Final decision

Powercor electricity distribution determination
1 July 2026 – 30 June 2031

Attachment 3 – Operating expenditure

April 2026

Figure 3-4 HBRA spans cut and remaining, 2022 to 2025

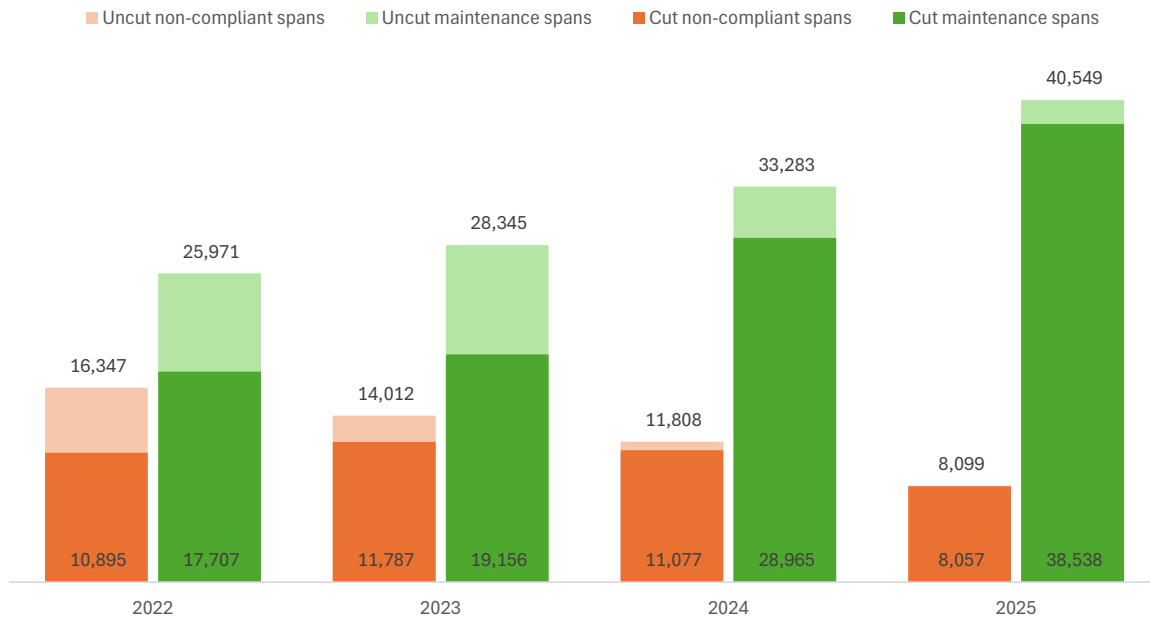
In the years since Powercor introduced LiDAR, it has not been able to rectify all the non-compliant spans it has identified. This can be seen in Figure 3-4 and Figure 3-5, which show the number of spans cut and remaining in Powercor’s high bushfire risk areas (HBRA) and low bushfire risk areas (LBRA). We can see that Powercor has made significant progress in its HBRA, but is less progressed in its LBRA.

We can see that the total number of spans (cut and remaining) has been largely steady over time. We are satisfied that these total cut counts provide a reasonable basis on which to forecast cutting volumes.

As such, Powercor’s proposal represents a significant shift in the recent trend in the volume of hourly rate cuts. As shown in Figure 3-4, Powercor has improved its compliance and reduced the number of spans with vegetation growing into the minimum clearance space. Part of the justification for this step change is to minimise ‘grow ins’, since no vegetation is allowed inside the minimum clearance space. We would expect the number of hourly rate cuts required should reduce as Powercor continues to improve its vegetation clearance compliance.
